# IMMINGHAM EASTERN RO-RO TERMINAL

Proposed Changes Notification Report

Document Reference 10.3.2

PINS Reference – TR0300072023

**Figure 6 – Proposed rearrangement of UK Border Force facilities**

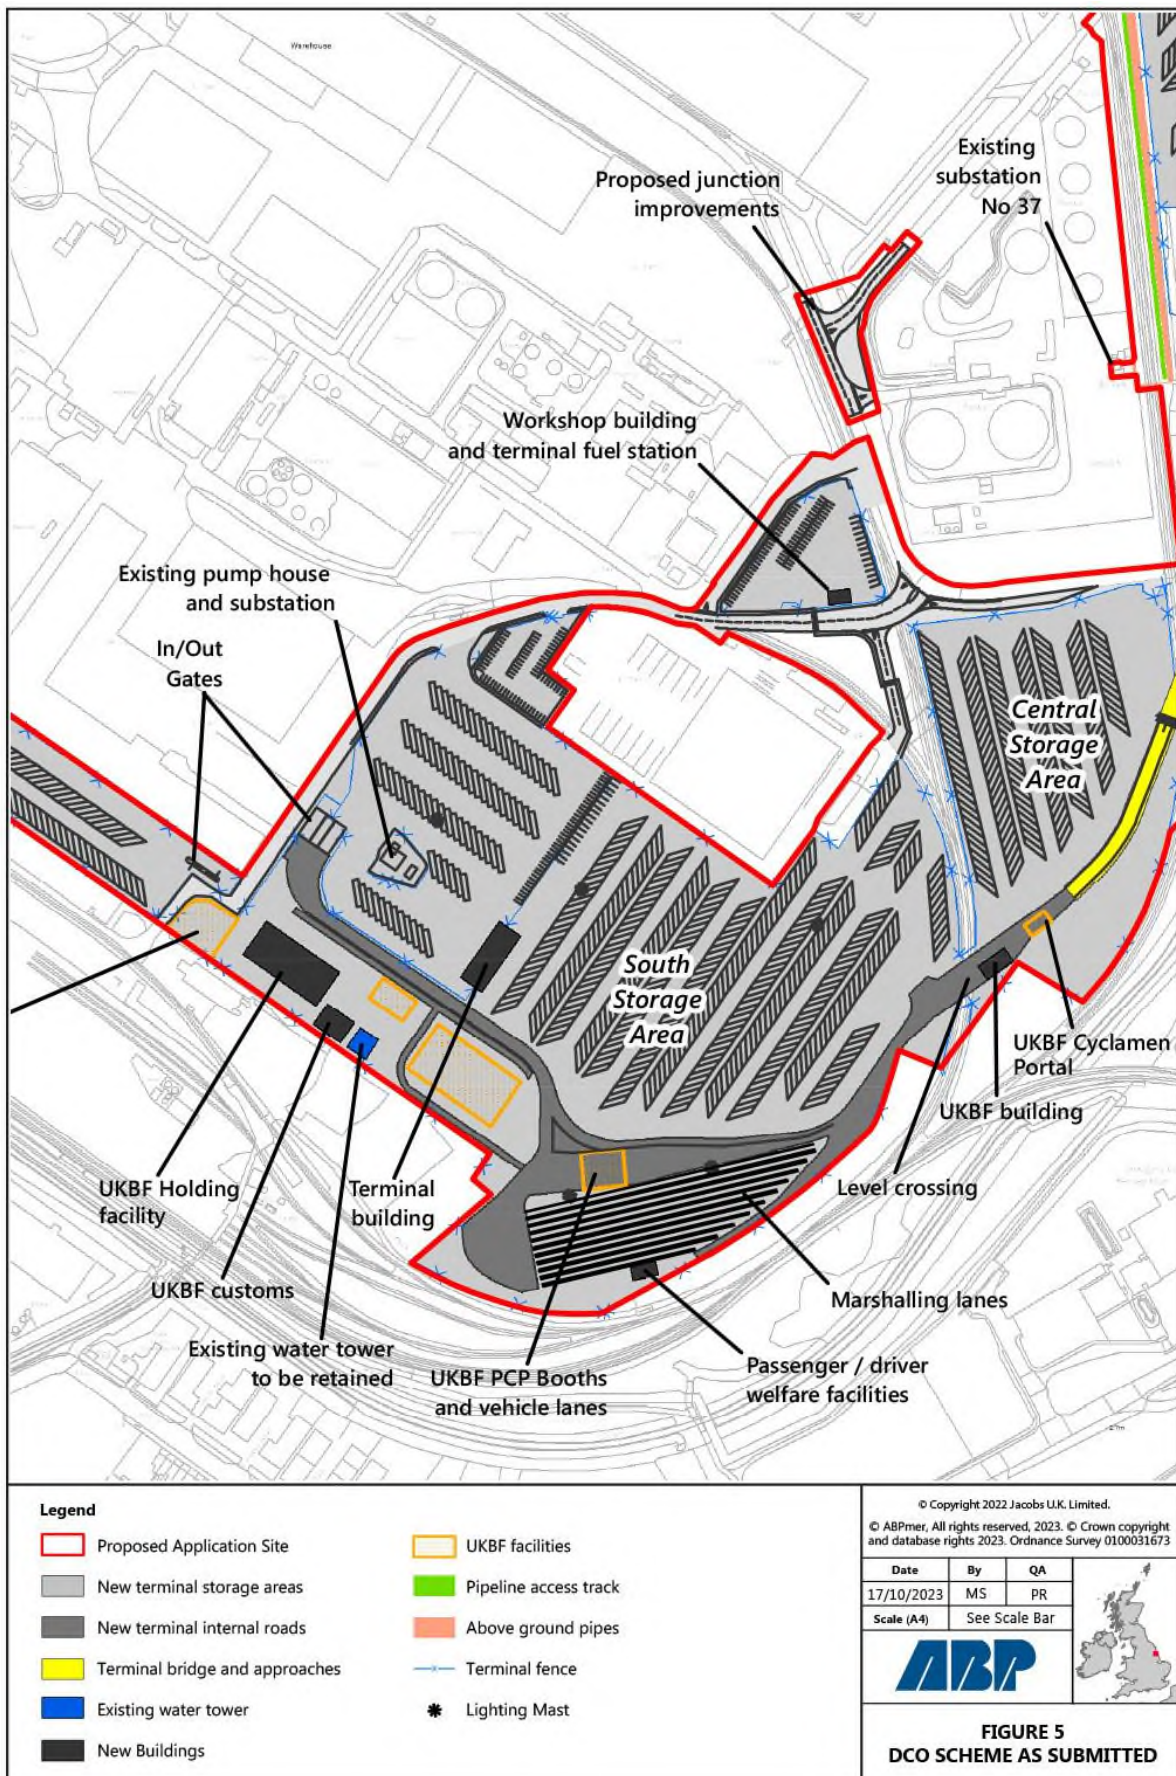
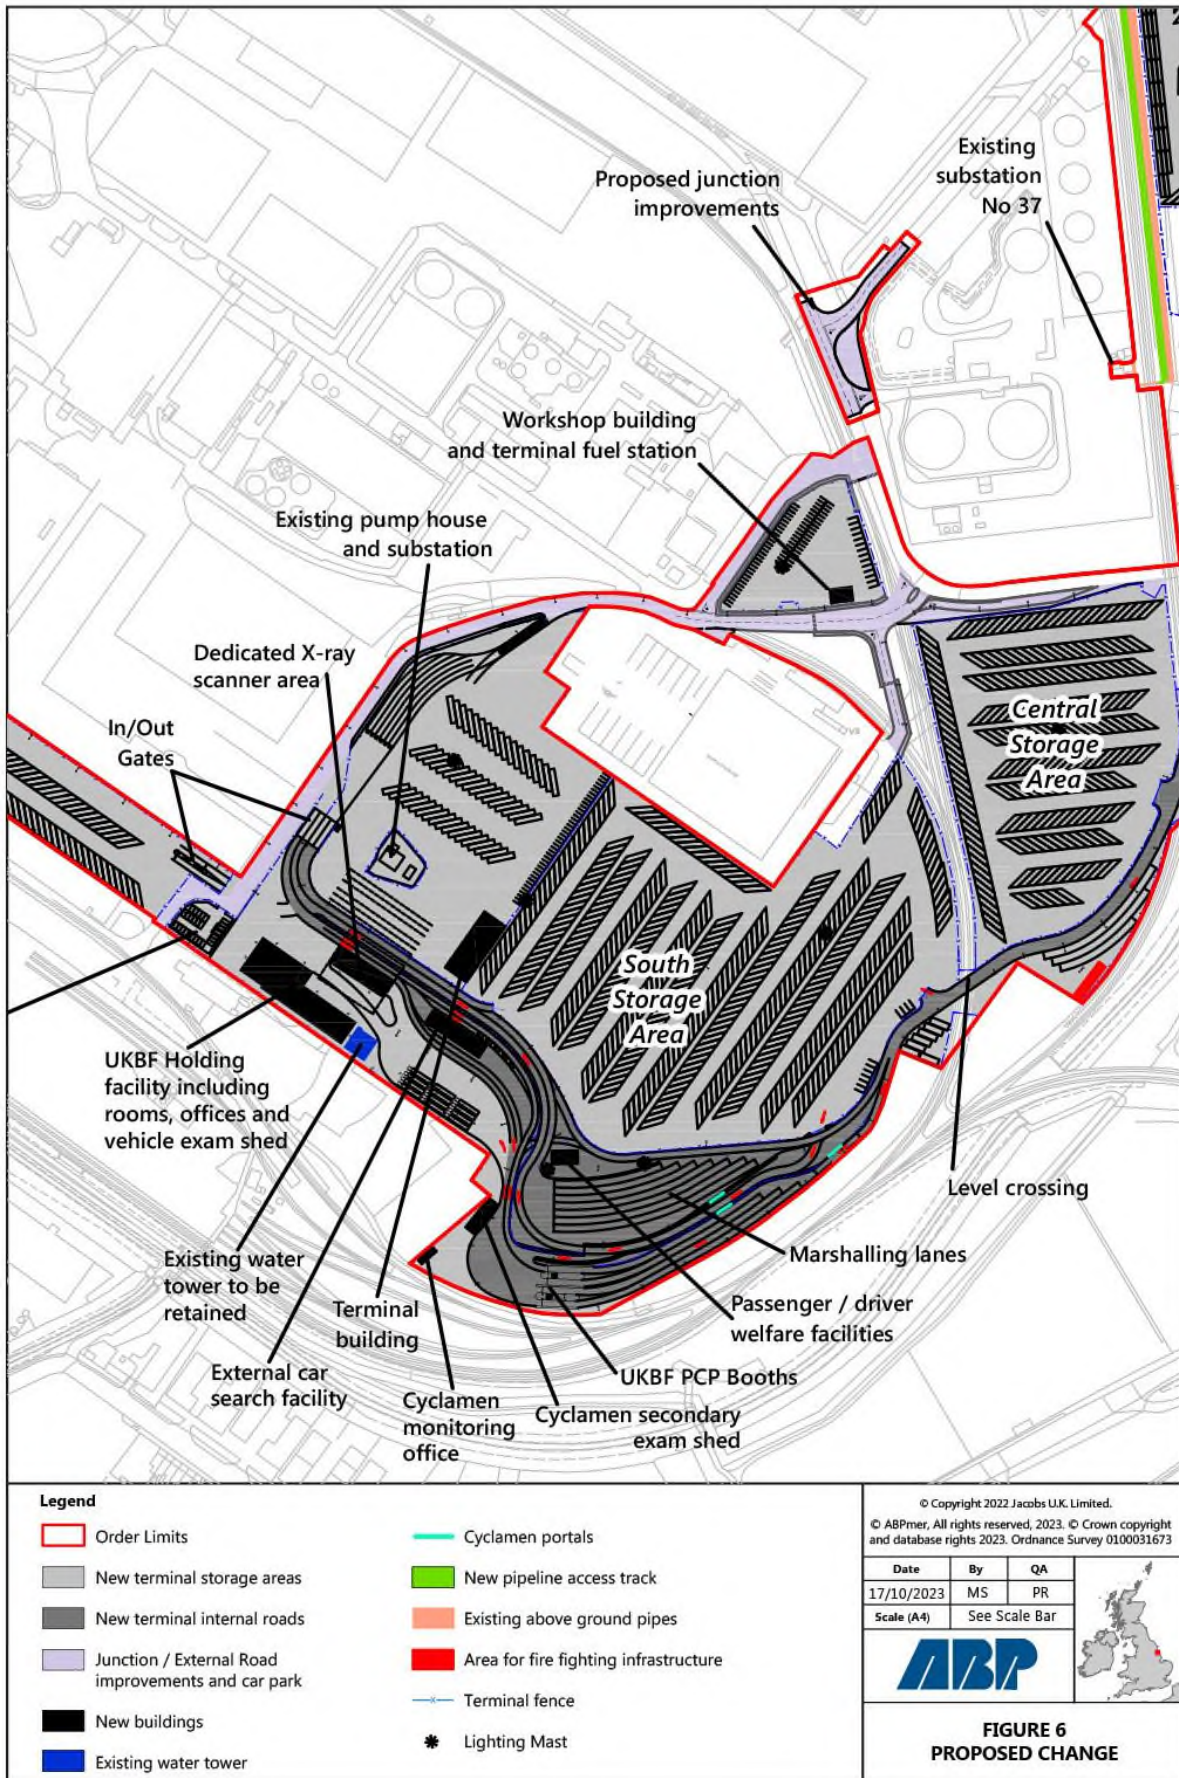
- 2.24 The area within which the UKBF facilities will be located has not changed since submission, but the general layout and the location of the facilities has changed to reflect UKBF's stated preferences.

- 2.25 In addition, in consultation with UKBF, changes are proposed to the operational layout to enhance the efficiency, safety, and security of the facility. For example, the inbound road and associated passport control booths have been moved to the southern boundary with the shift of the marshalling lanes to move slightly northwards.

- 2.26 Figures 5 and 6 below show how the originally submitted scheme would be amended if this proposed Change 3 is accepted. Further details are provided in the ES Addendum (Appendix 1) at paragraph 2.4.

Figure 7 – Change to the Conditional Proposed Impact Protection Measures

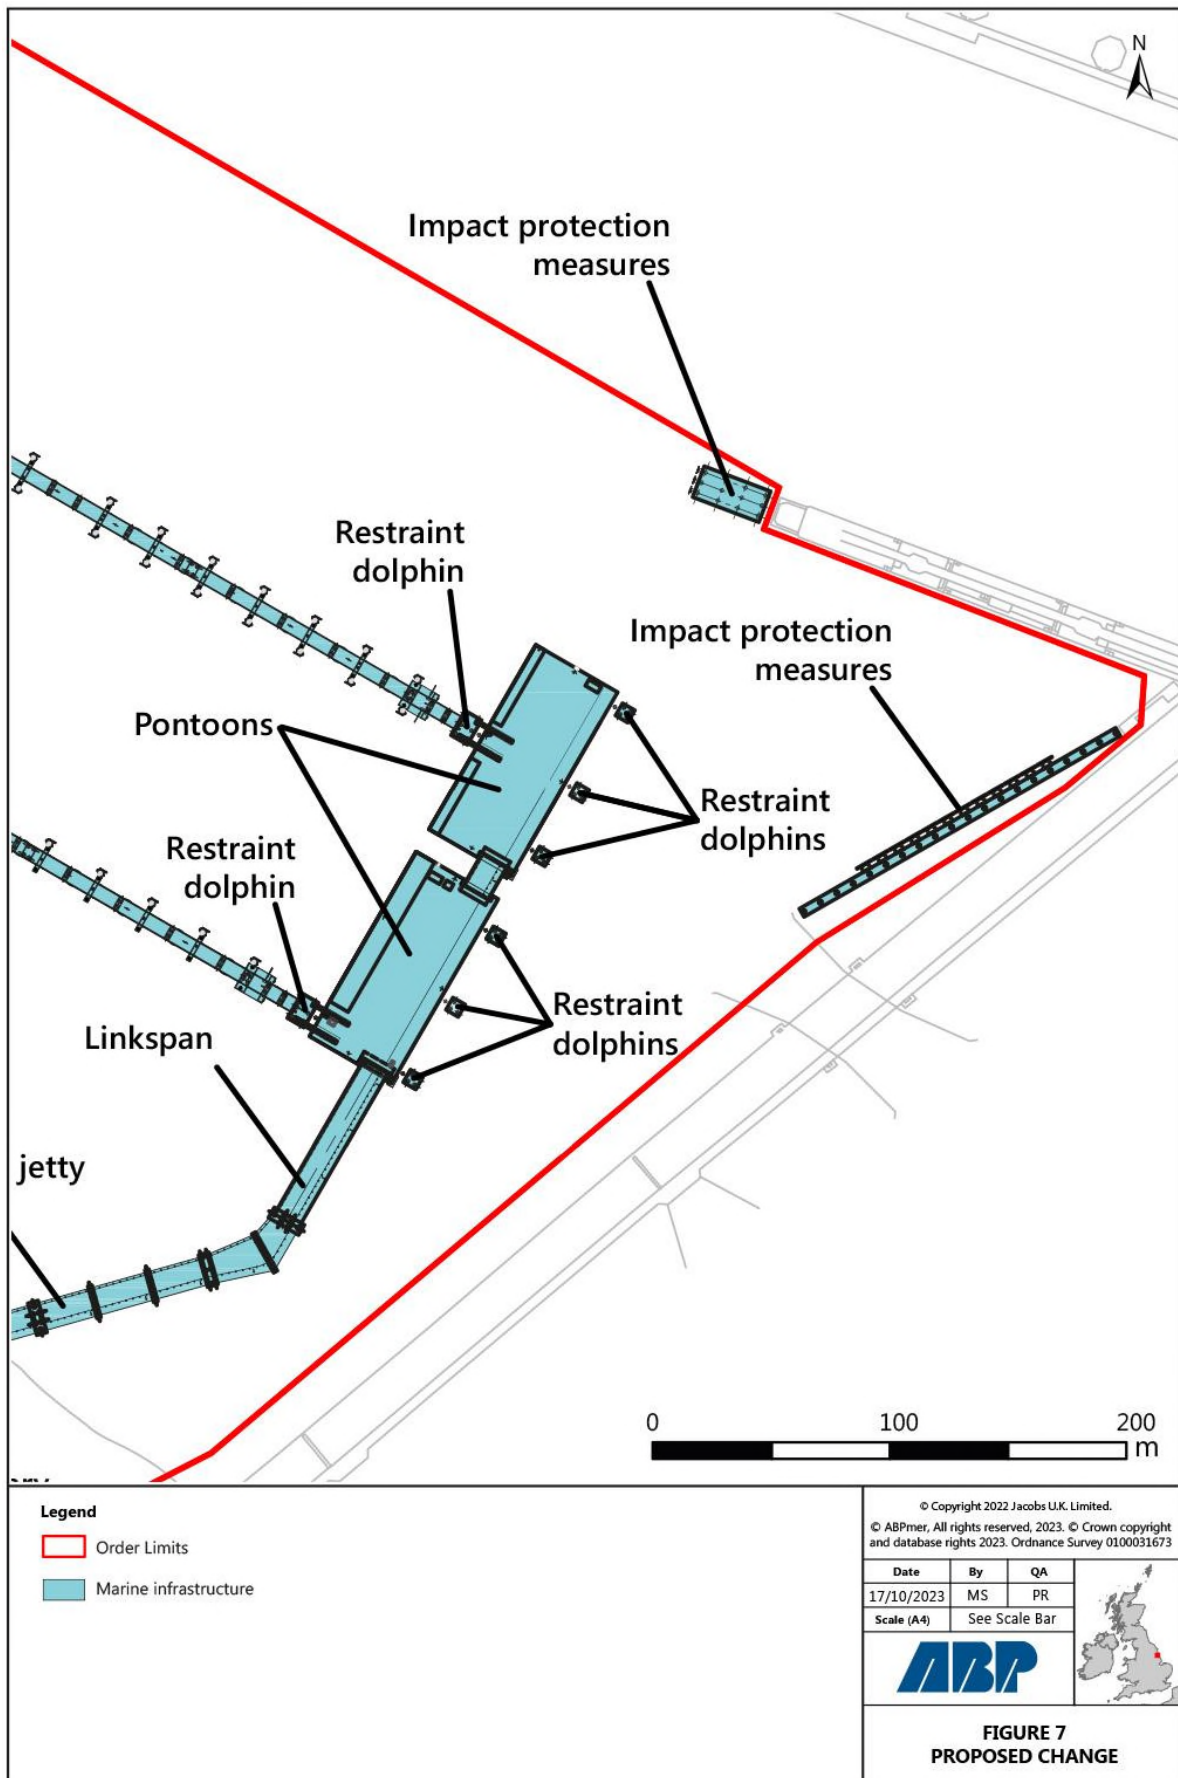
- a) **Linear protection** – The Applicant will retain the conditional provision of the linear protection barrier for the IOT trunkway as already identified in Schedule 1 of the submitted DCO application, (Work No. 3 as shown on the General Arrangement Plans); and

- b) **Additional protection barrier** – In addition, the Applicant also proposes, again conditionally, to add – either as a new Work or as an addition to the current Work No.3 - the ability to construct a protection barrier to be located at the western end of the IOT finger pier.

- 2.45 The rationale and need for these proposed changes/amendments are discussed in more detail in section 3.
- 2.46 The proposed conditional scheme changes in relation to the provision of impact protection measures are illustrated at Figure 7.

3.40 Work No. 3 currently comprises the linear protection barrier fronting the trunkway. The description of that Work will, however, be amended as part of the proposed Change Application to include the western finger pier protective barrier as noted at paragraph 2.23(b).

**Figure 8 - Beckett Rankine scheme**

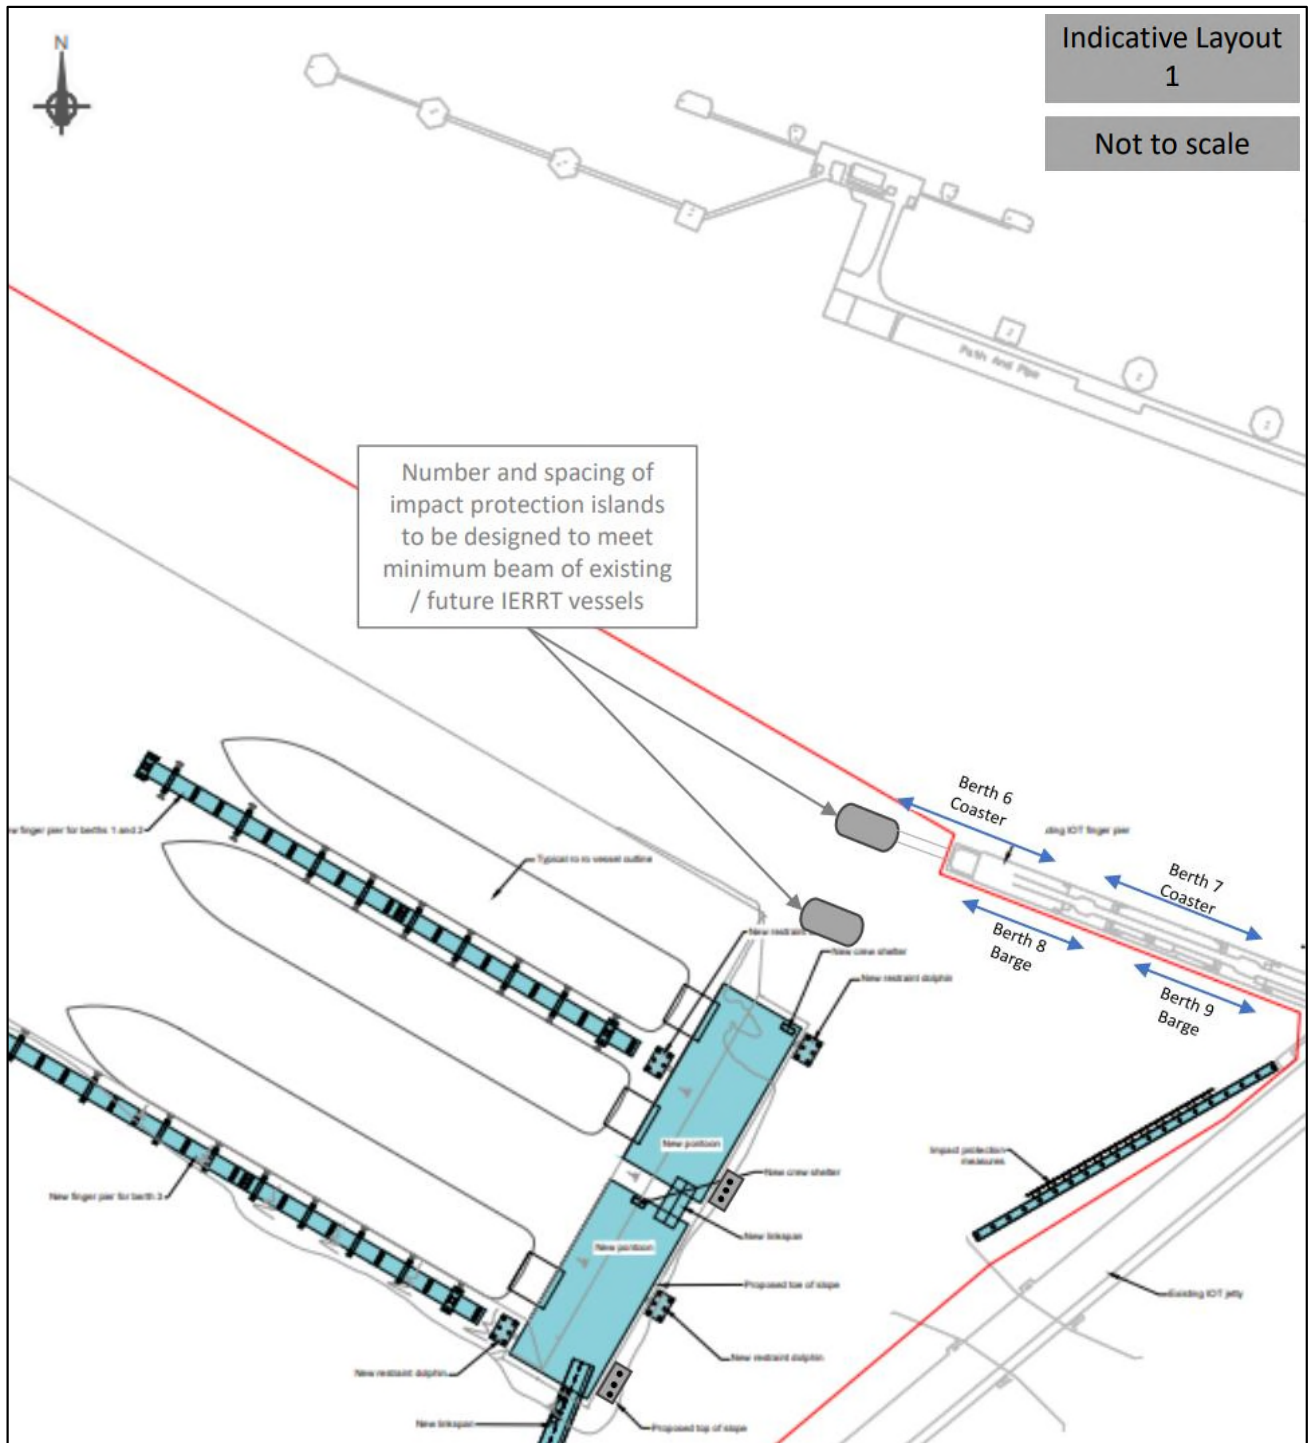
3.23 A plan of the original Beckett Rankine scheme is provided at Figure 8 below.

- a) 2 x "impact protection islands" with a maximum gap of 25m (no greater than the beam of the smallest IERRT design vessel);
  - b) The impact protection structures should be independent of any extension of the finger pier, with sufficient clearance to ensure separation from the finger pier in case of allision;

- a) **The size of the impact protection structures** – the requirement to design impact protection structures to accommodate the largest design vessel travelling at a maximum current speed of 4 knots resulted in a plan area of each impact protection structure in the order of 45m long by 25m wide by 30m high. This compares to an approximate size of 20m by 10m as shown in the Beckett Rankine sketch. One impact of such a significant size increase would be the introduction of a significant additional navigational constraint, to both IOT and the proposed IERRT operations.

- d) ***The navigational impact of the finger pier extension*** – whereas the Beckett Rankine plan was intended to accommodate two coaster vessels on the northern face of the finger pier in the arrangement shown, the stated requirements of the IOT Operators which have emerged are based on providing an extension of approximately 130 metres to the finger pier. This extension, along with the provision of the large impact protection structures (identified above) result in an encroachment into the navigational area of IERRT and increase the risk of allision (in contrast to what was illustrated in the Beckett Rankine plan).
